SERVICE MANUAL

BE-3D CHASSIS

SUPPLEMENT - 2

SUBJECT : CHANGE OF PART NUMBERS

6-1. CHASSIS

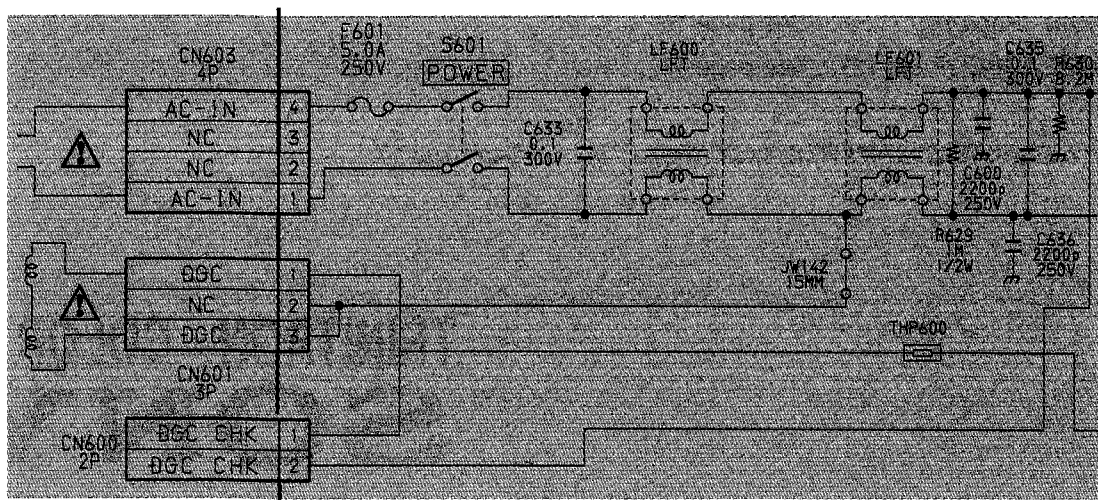
6-1. CHASSIS (Page 71) See page 15
